APPLICATION

SEWAGE DISPOSAL TESTING

HOWARD COUNTY HEALTH DEPARTMENT
ENVIRONMENTAL HEALTH SERVICES

PROPERTY LOCATION: BRIGHTON PINES II LOT 16

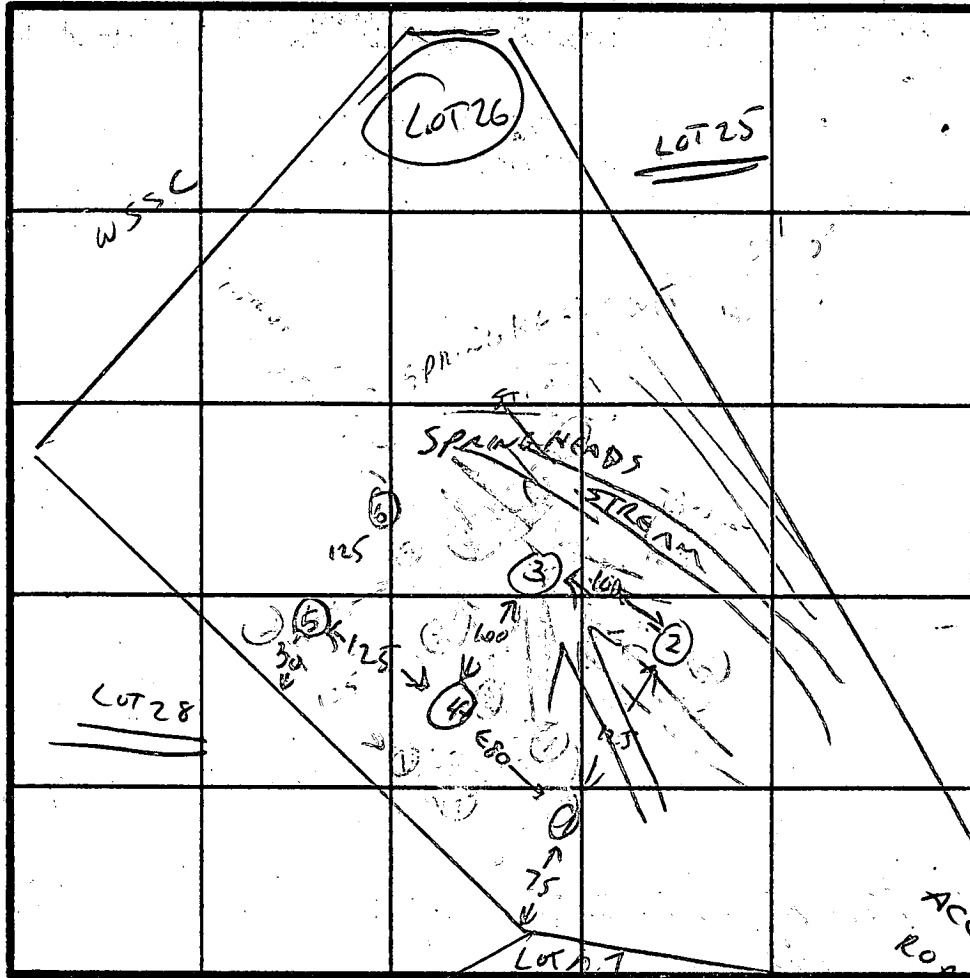
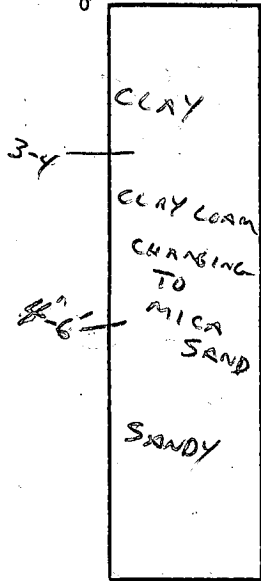
REASONS FOR REJECTION OR HOLDING FIELD INSPECTION REQUIRED, ORIGINAL LAYOUT

INCLUDES DRAINAGE SWALS - MUST BE RELOCATED USING 160LBS 5TB 2-18-84 CW

ALL HOLES OK - LAYOUT NEEDS ADJUSTMENT TO AVOID DRAINAGE PROBLEMS.
REMARKS DRAINAGE AREA IN CENTER OF PLOT AREA SPRING HEADS ADJACENT TO LAYOUT UNACCEPTABLE
